AGENDA
Polson City–County Planning Board
Tuesday December 8, 2015 @ 6:00 P.M.
Polson City Hall Council Chambers

New Business: Special Use Permit #15-09 DCI -Dialysis Clinic Incorporated

Polson City-County Planning Board
Tuesday, December 8, 2015 at 6:00 PM
Polson City Council Chambers
Special Use Permit for the proposed DCI Dialysis Clinic

date 09/15/2015
project no. 34-140
sheet no. C3.00
SITE LAYOUT PLAN

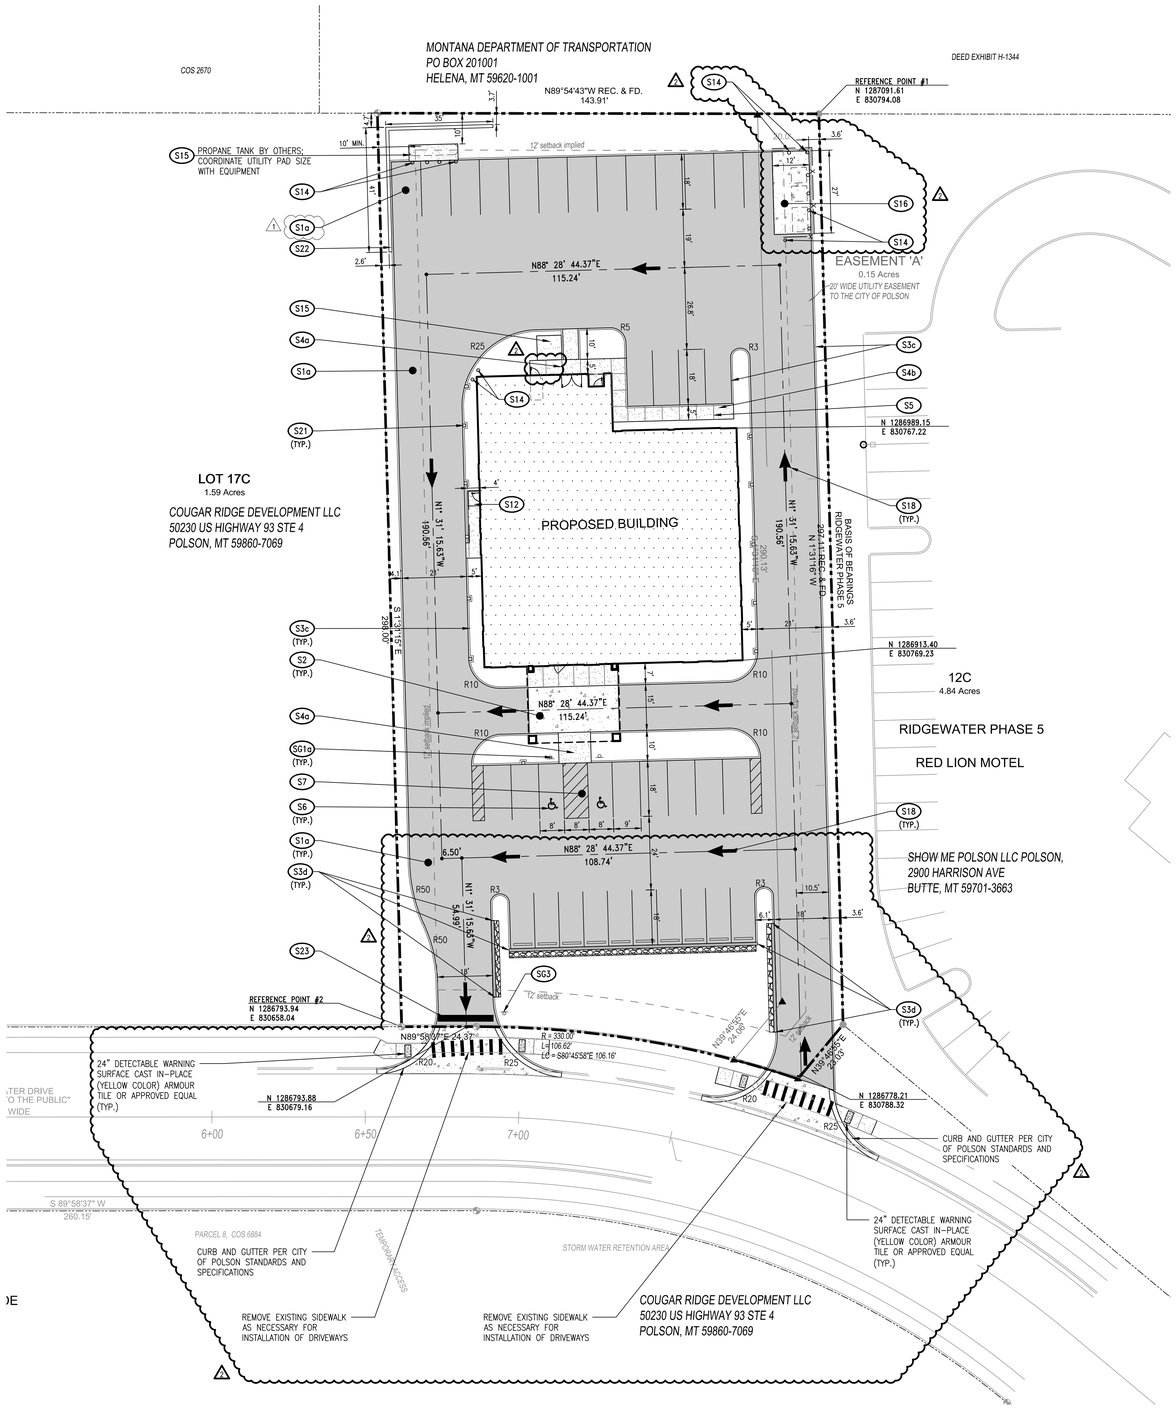
-There is a 12 foot landscape buffer. Trees are required as per the Polson Development Code with four major trees in each hundred lineal feet of buffer. The front buffer being approximately one-hundred lineal feet, plans show only two major trees – there should be four.

11. A 12' landscape buffer shall be installed along the Ridgewater streetscape that meets the requirements and standards of the Polson Development Code Appendix F. Trees are required as per the Polson Development Code with four major trees in each hundred lineal feet of buffer. The front buffer being approximately one-hundred lineal feet, plans show only two major trees – there should be four.

date 09/15/2015
project no. 34-140
sheet no. C5.00
UTILITIES PLAN

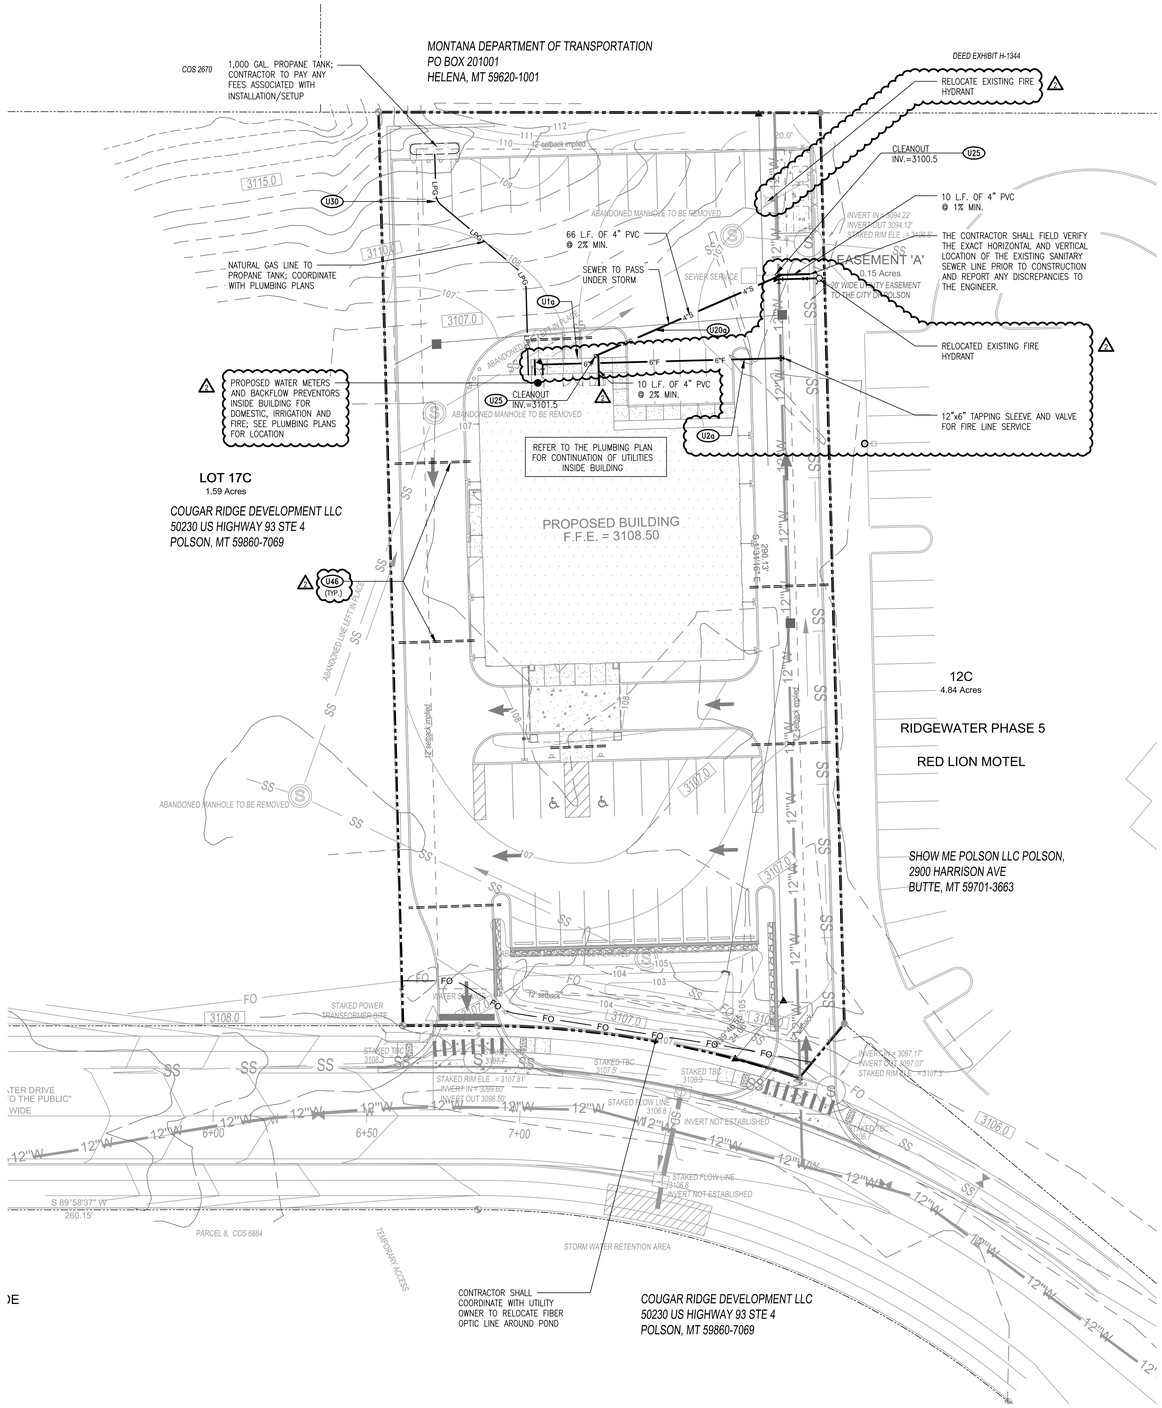
-Applicant has requested to relocate the fire hydrant south of its current location in the very northeastern corner of the property. This is permitted; however, the fire line must continue to the north end of the property as originally indicated.
